Service Bulletin No: 91-001
Modification No: EC-19-0553

**AIR VEHICLE WIRING - GENERAL
IMPROVEMENTS TO THE AIRCRAFT ELECTRICAL HARNESS INSTALLATION**

PC-24 aircraft MSN 101 thru MSN 160.

To improve the electrical harness installation, at various locations throughout the aircraft, to prevent the possibility of the electrical harness chafing on the structure and/or moving parts.

Improvements to the electrical harness installation - Avionics rack
Figure 3 (Sheet 4 of 4)

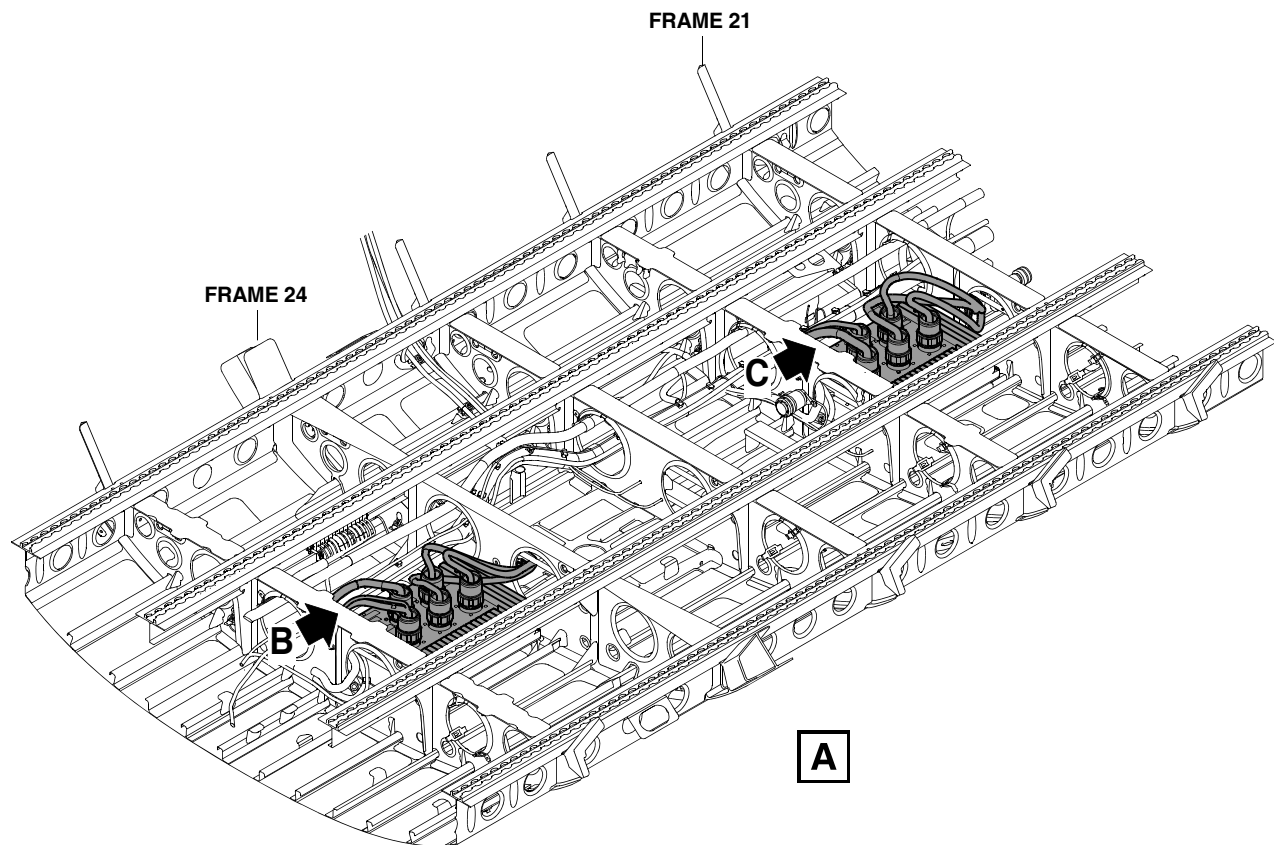
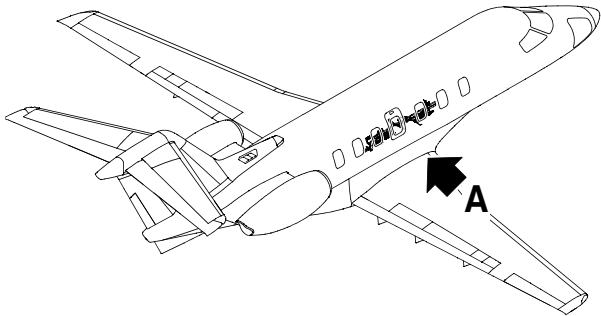
- (5) Improvement to prevent the electrical harness from chafing on the SYS2 electrical harness. Refer to Figure 3 (Sheet 4)

In the avionics rack, at the rear of the Multi-Mode Digital Radio (MMDR) 2, on the electrical harness that comes from the electrical connector AR1641P1:

- (a) Cut and remove the necessary cable ties from the electrical harness (10) to get sufficient access to install the new protection sleeve (12).
- (b) Cut a new piece of protection sleeve (12) (P/N 917.96.92.154) to a length of 2.36 in (60,00 mm).
- (c) Remove/Install tape (Silicone red, fiberglass) (Material No. P09-064), as necessary, so that you can install the new protection sleeve (12) on the electrical harness (10).
- (d) Put the new protection sleeve (12) in position on the electrical harness (10) so that it is fully against the backshell of electrical connector (11) (AR1641P1).
- (e) Use the applicable new cable ties (Material No. P09-005/P09-008/P09-014) to:
 - Attach the protection sleeve (12) to the electrical harness (10)
 - Replace any cable ties that you cut and removed to get access.

Improvements to the electrical harness installation - Fuselage
Figure 4 (Sheet 2 of 3)

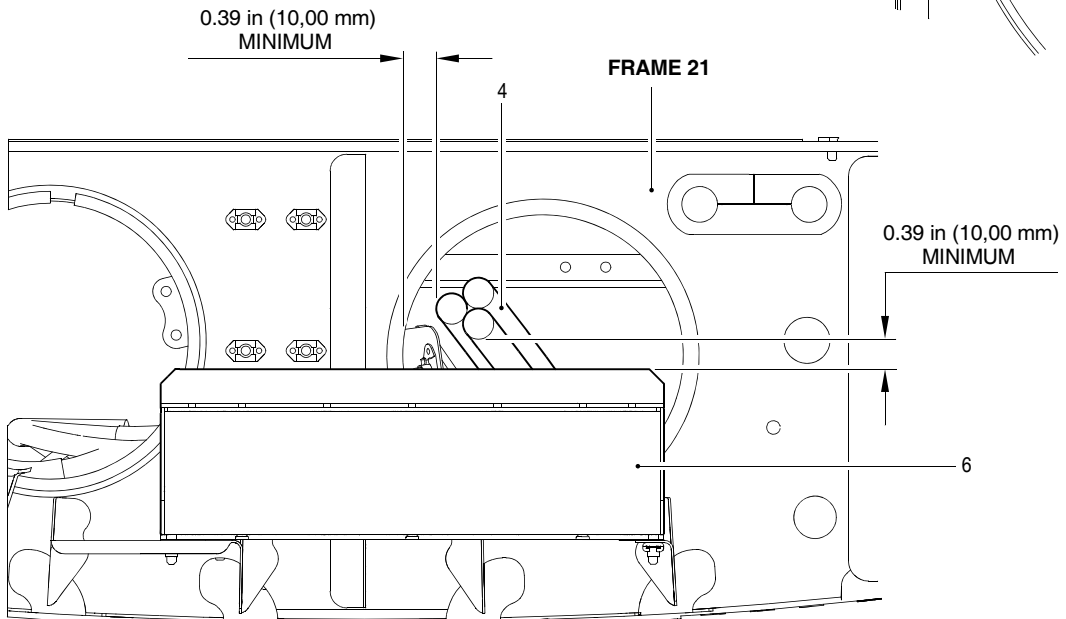
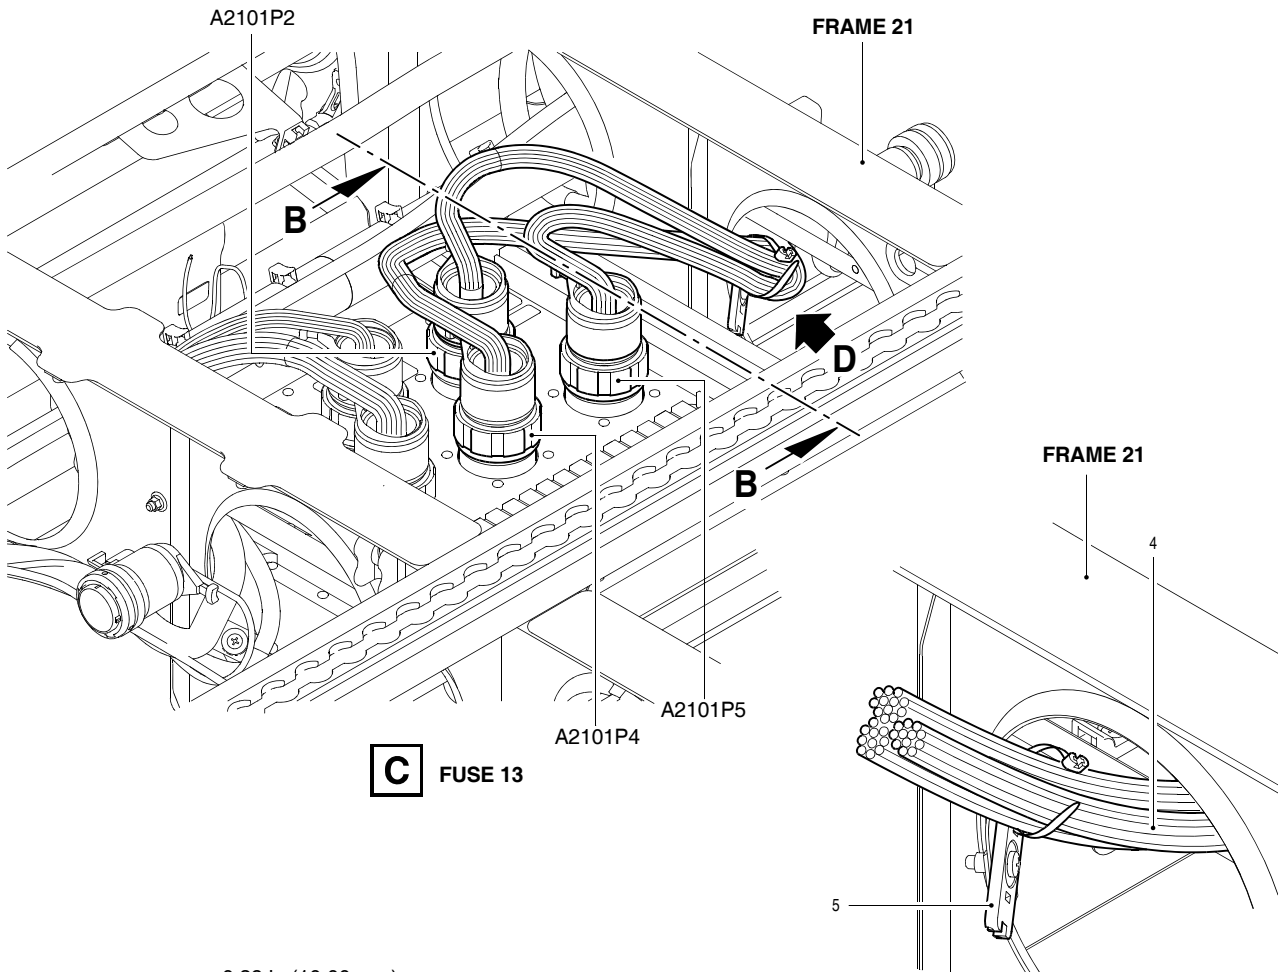
- (1) Improvement to prevent the electrical harnesses from chafing on the DCPU 3 and Frame 24. Refer to Figure 4 (Sheet 2)

- (a) Do a check to see if the distance between the electrical harness (2), and the DCPU 3 (3) and Frame 24 is ≥ 0.39 in (10,00 mm).
- (b) If the distance between the electrical harness (2), and the DCPU 3 (3) and Frame 24 is not ≥ 0.39 in (10,00 mm):
 - 1 Cut and remove the necessary cable ties to get sufficient access to modify the route of the electrical harness (2).
 - 2 Remove/Install tape (Silicone red, fiberglass) (Material No. P09-064), as necessary.
 - 3 Use the applicable new cable ties (Material No. P09-005/P09-008/P09-014) to:
 - Modify the route of the electrical harness (2) so that there is a minimum distance of 0.39 in (10,00 mm) between the DCPU 3 (3) and Frame 24. If necessary, move the cable mount (1) to a different orientation
 - Replace any cable ties that you cut and removed to modify the route of the electrical harness (2).

Improvements to the electrical harness installation - Fuselage
Figure 4 (Sheet 3 of 3)

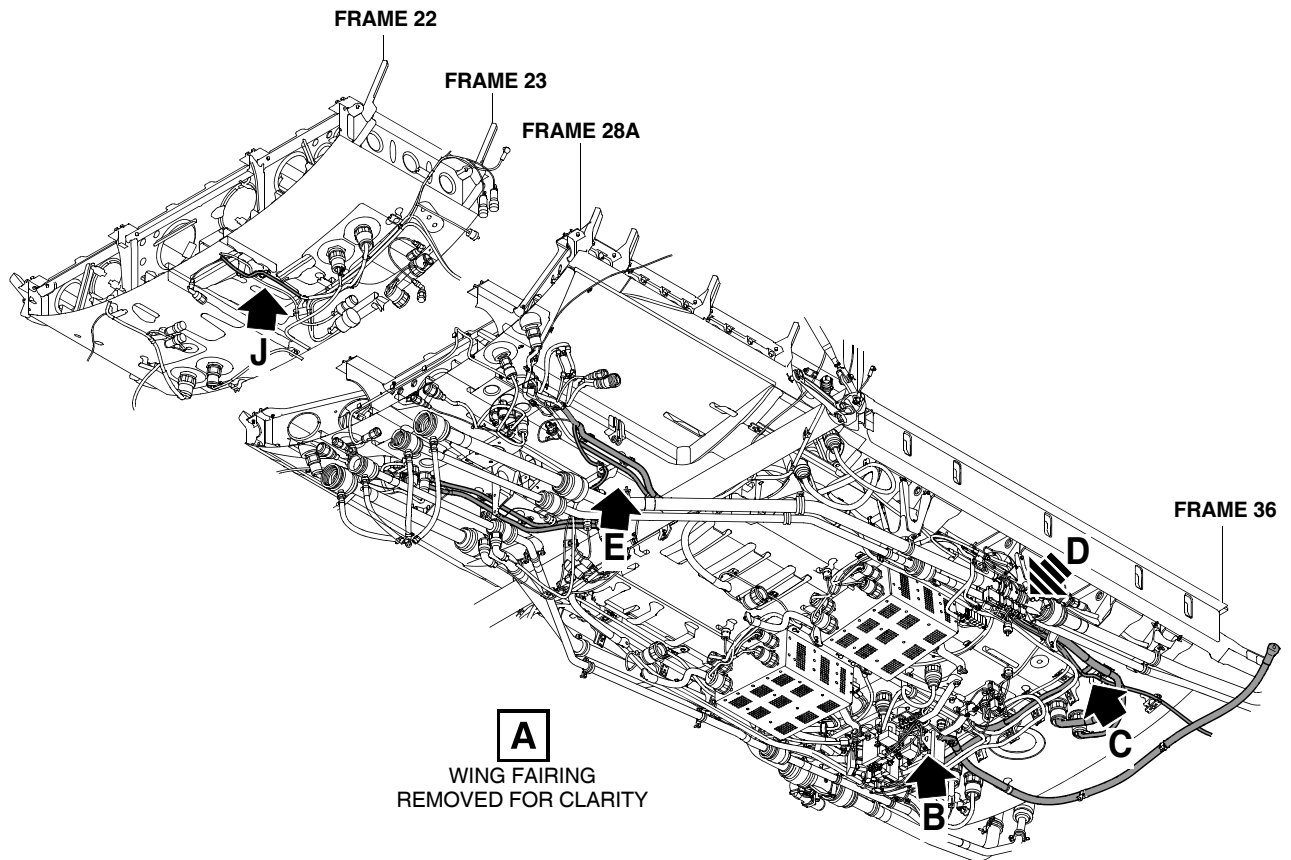
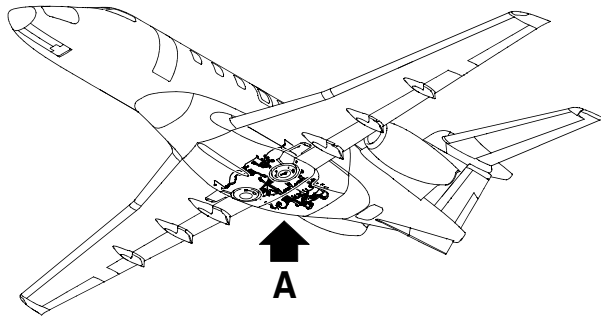
- (2) Improvement to prevent the electrical harness from chafing on the DCPU 1 and Frame 21. Refer to Figure 4 (Sheet 3)

- 1 Cut and remove the necessary cable ties to get sufficient access to modify the route of the electrical harness (4).
 - 2 Remove/Install tape (Silicone red, fiberglass) (Material No. P09-064), as necessary.

- Modify the route of the electrical harness (4) so that there is a minimum distance of 0.39 in (10,00 mm) from the DCPU 1 (6) and Frame 21
 - Replace any cable ties that you cut and removed to modify the route of the electrical harness (4).

Improvements to the electrical harness installation - Wing fairing
Figure 5 (Sheet 2 of 9)

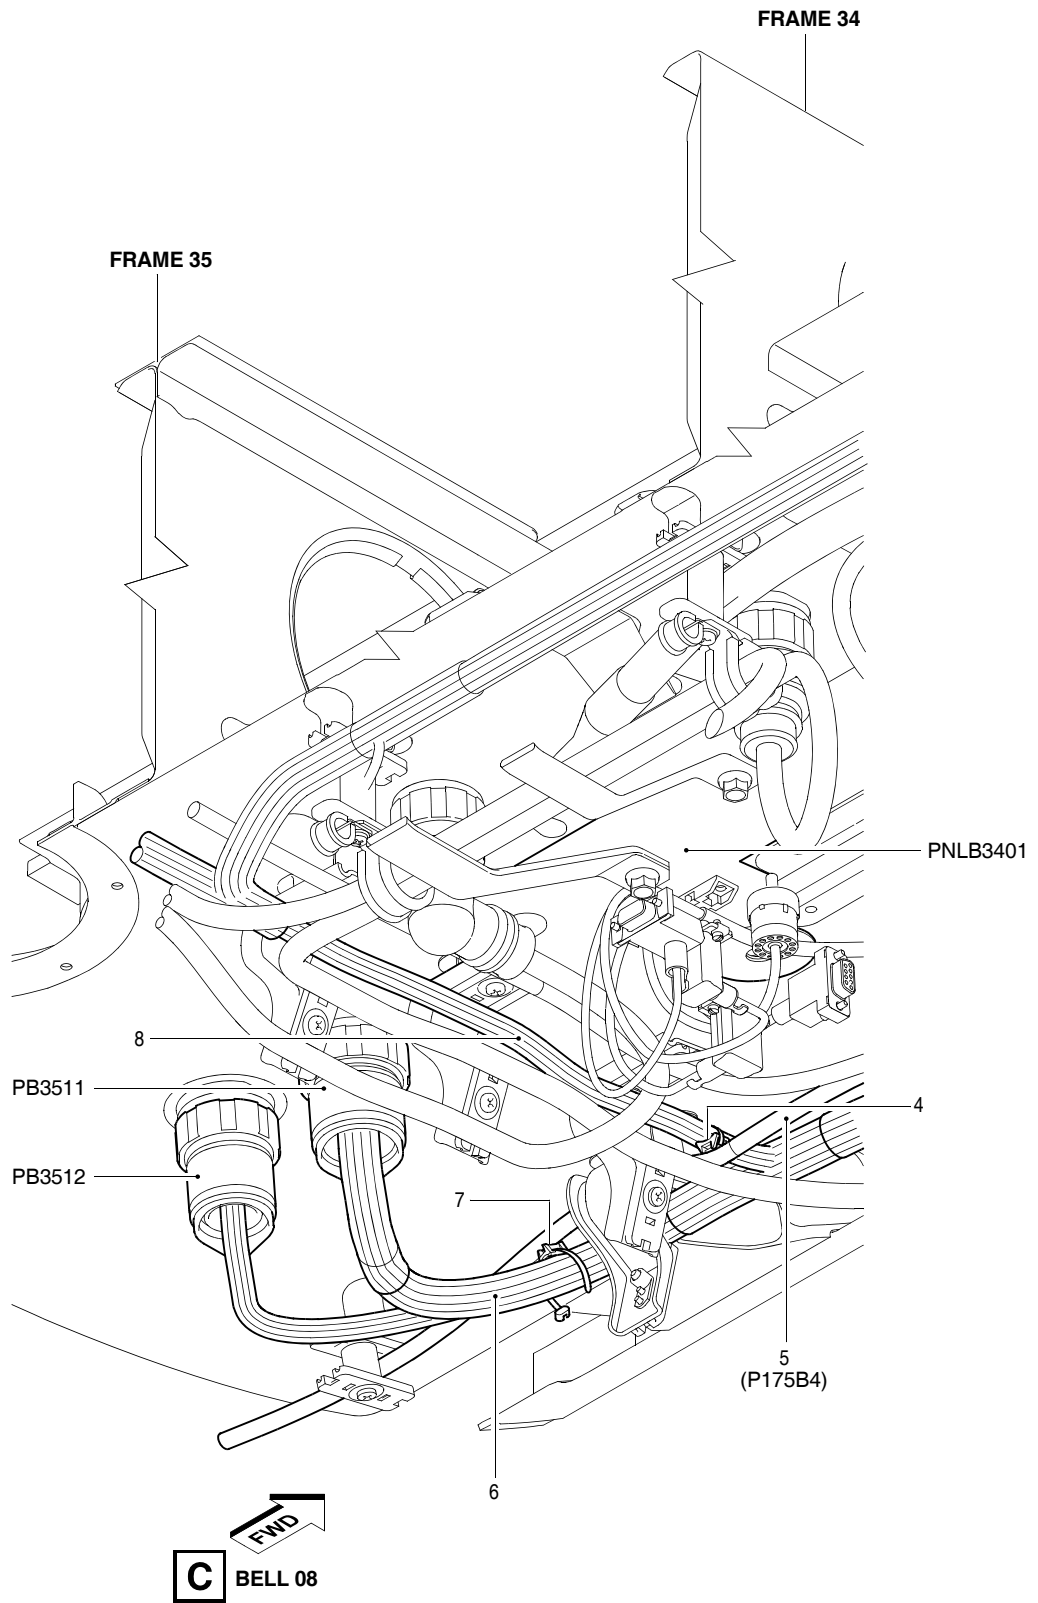
- (1) Improvement to prevent the electrical harness from chafing on the power cable. Refer to Figure 5 (Sheet 2)

- (a) Cut and remove the necessary cable ties from the electrical harness (2) and/or the power cable (1) (P115A0000) to get sufficient access to install the new spacer (3) (P/N 971.32.18.108).
- (b) Put new tape (Silicone red, fiberglass) (Material No. P09-064) around the electrical harness (2) and the power cable (1) (P115A0000) at the new spacer (3) installation position.
- (c) Put the new spacer (3) (P/N 971.32.18.108) in position between the electrical harness (2) and the power cable (1) (P115A0000).
- (d) Use the applicable new cable ties (Material No. P09-005/P09-008/P09-014) to:
 - Attach the spacer (3) between the electrical harness (2) and the power cable (1) (P115A0000)
 - Replace any cable ties that you cut and removed to get access.

Improvements to the electrical harness installation - Wing fairing
Figure 5 (Sheet 3 of 9)

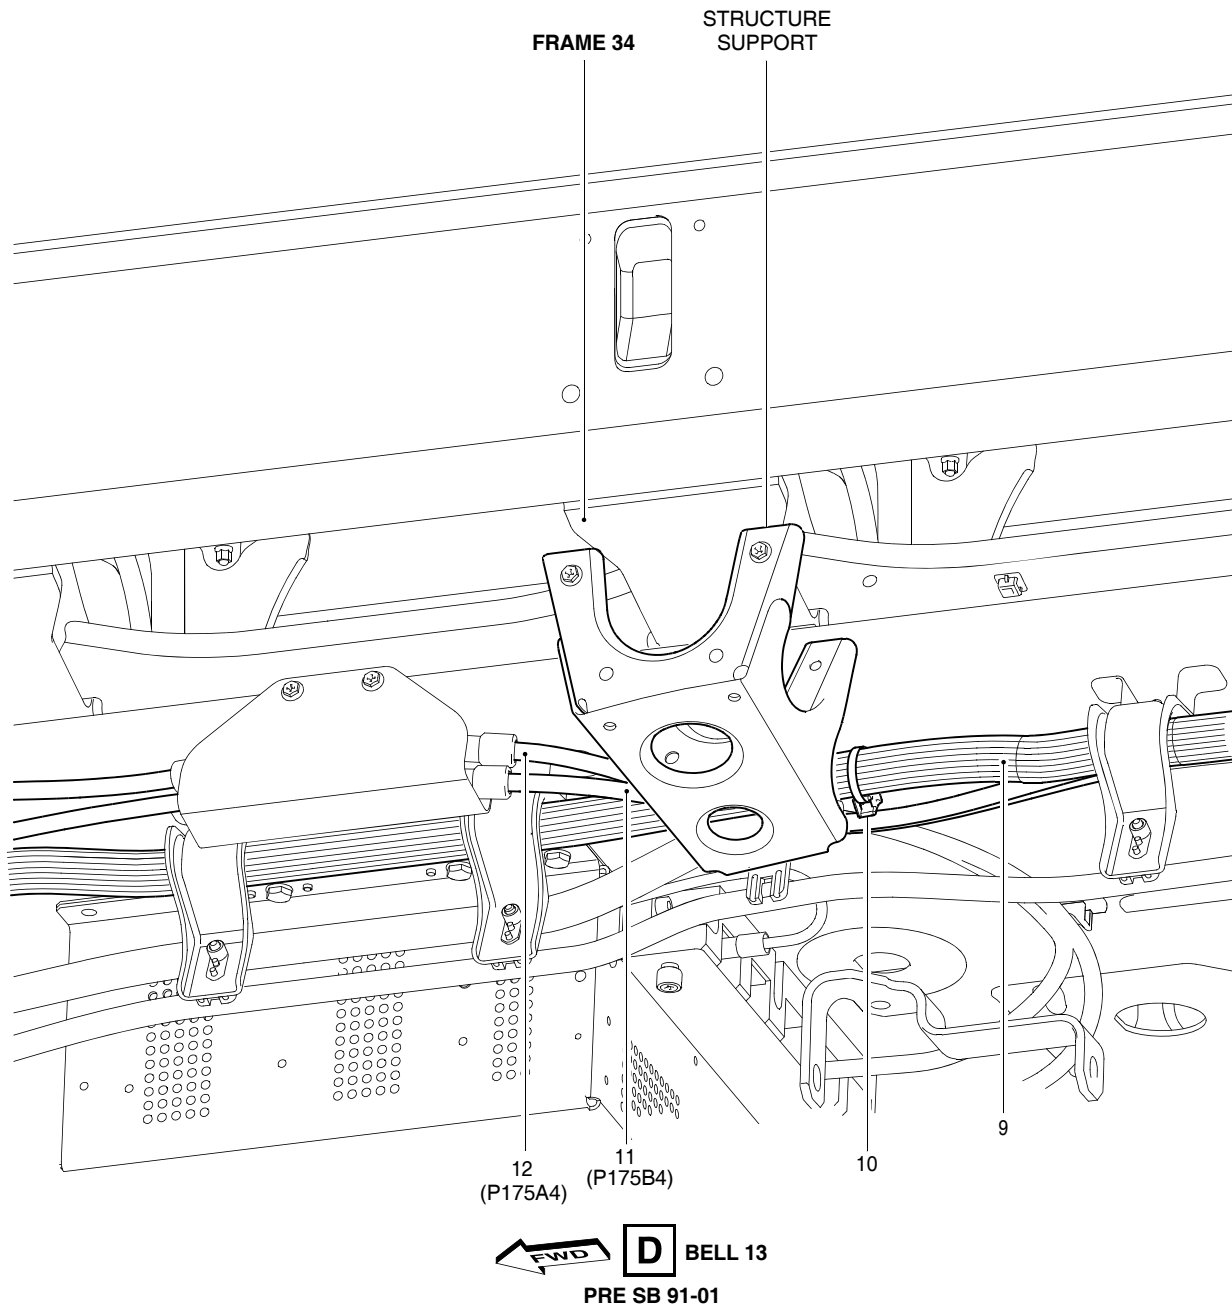
- (2) Improvement to prevent the electrical harness from chafing on the power cable.
Refer to Figure 5 (Sheet 3)

- (a) Cut and remove the necessary cable ties from the electrical harnesses (6) and (8), and/or the essential feeder cable (5) (P175B4) to get sufficient access to install the two new spacers (7) and (4) (P/N 971.32.18.108).

- Attach the two spacers (7) and (4) between the electrical harnesses (6) and (8), and the essential feeder cable (5) (P175B4)
 - Replace any cable ties that you cut and removed to get access.
